**CERTIFICATE OF APPROPRIATENESS**

**Property:** 1754 North Blvd., Lot 1, Block 5, Ormond Place Subdivision. The property includes a historic 4,409 square foot two-story single-family residence and a two-story detached garage situated on a 10,500 square foot (75' x 140') corner lot.

**Proposal:** Alteration – *Windows, Doors, and Addition with attached garage that connects existing closed in two story historic garage and primary residence.*

**Recommendation:** **Approval with conditions: retain existing opening dimensions for side door A1 facing Woodhead and repair exterior awning.**

WEST SIDE ELEVATION – FACING WOODHEAD

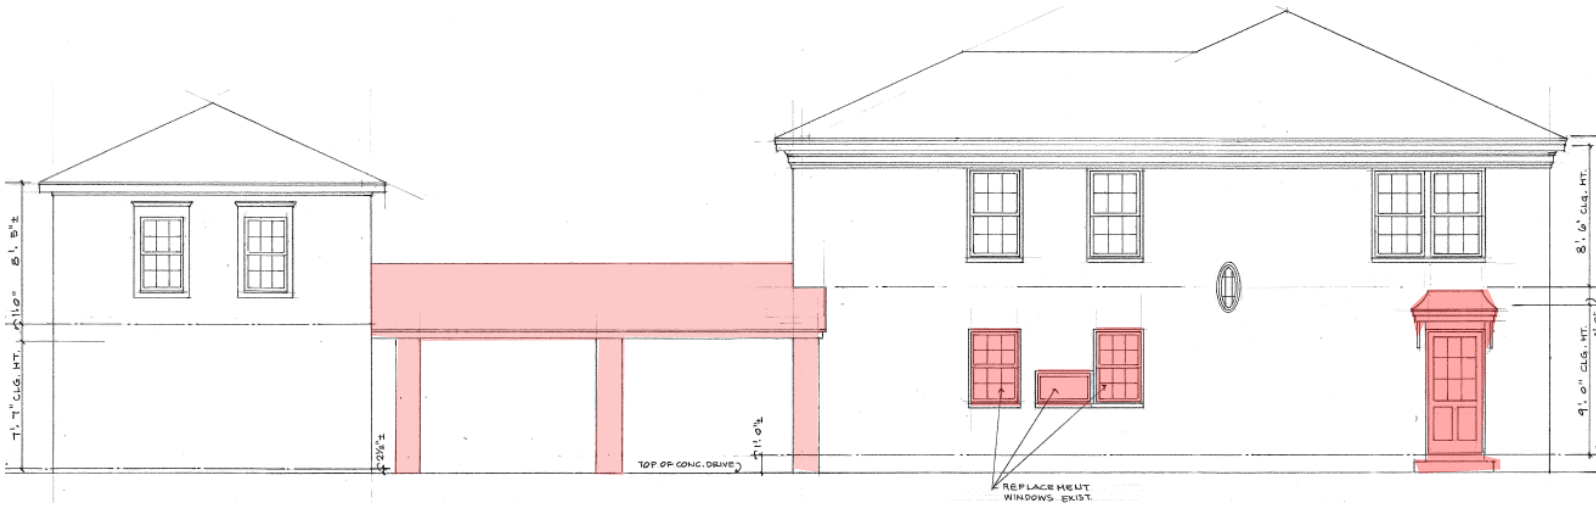
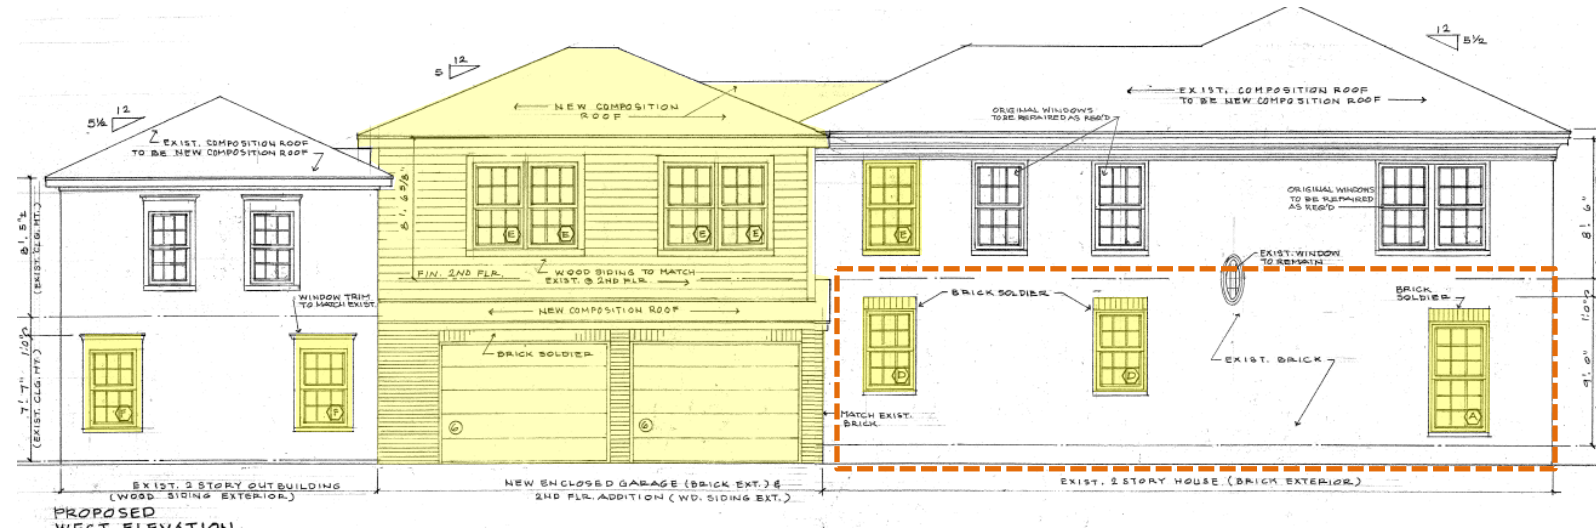
Altered windows to have vertical soldier courses, differentiated from front angled arrangement

**WINDOW PROPOSAL- alter existing door opening, replace with window to match front facade**

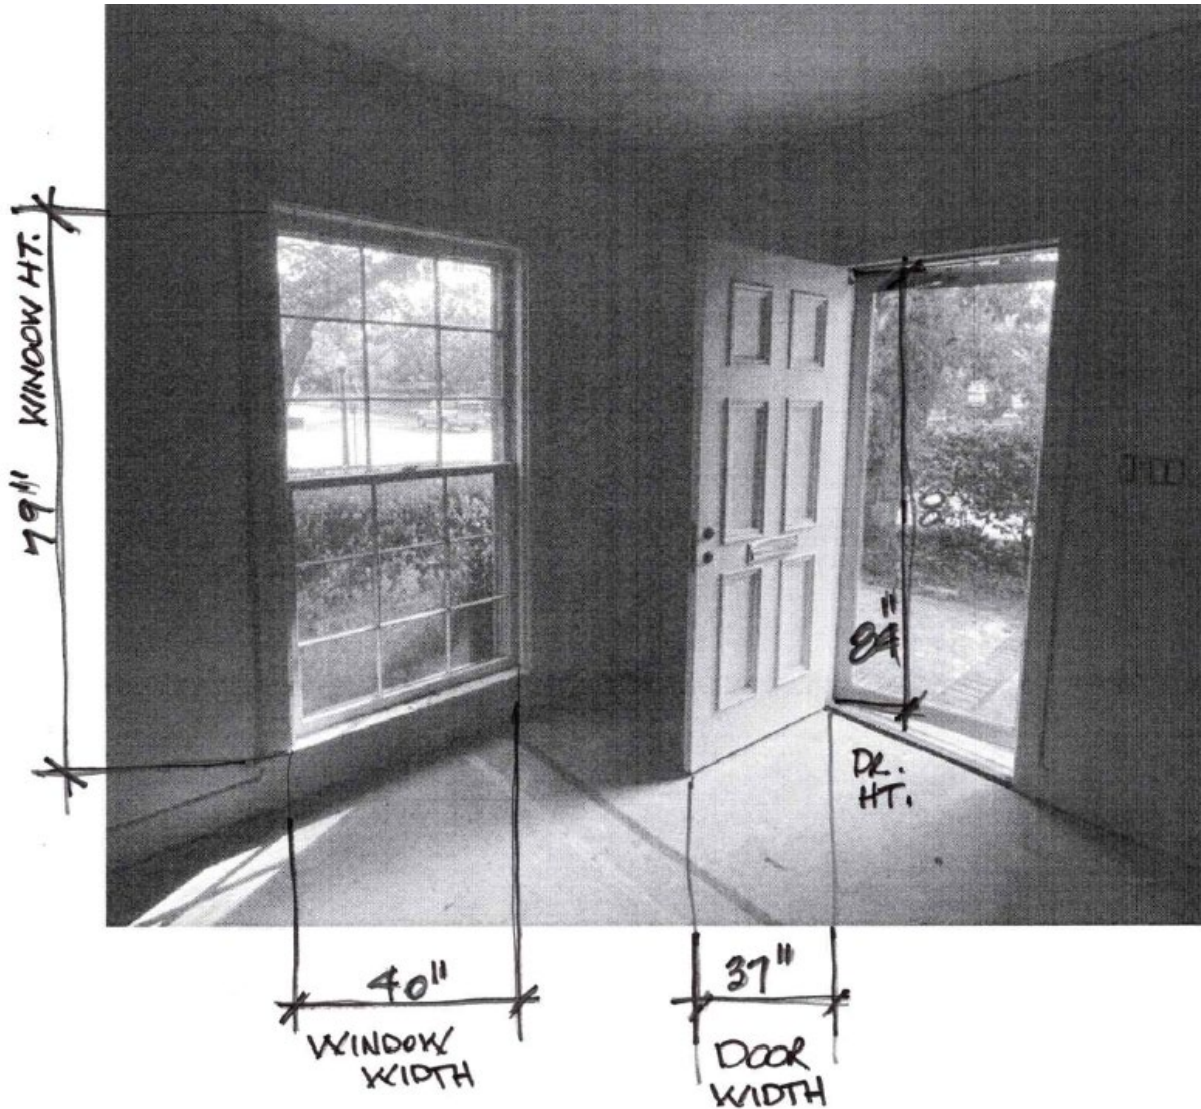
| <input type="checkbox"/>            | <input checked="" type="checkbox"/> | <input type="checkbox"/> | (4)                  | The proposed activity must preserve the distinguishing qualities or character of the building, structure, object or site and its environment;<br><i>If proposal retained existing door opening and awning of potentially historic side opening, this would preserve a distinguishing characteristic of the building.</i>                                   |                            |
| <input type="checkbox"/>            | <input checked="" type="checkbox"/> | <input type="checkbox"/> | (5)                  | The proposed activity must maintain or replicate distinctive stylistic exterior features or examples of skilled craftsmanship that characterize the building, structure, object or site;<br><i>If the proposal retained existing side door opening dimensions, historic brickwork would not be removed.</i>  |                            |
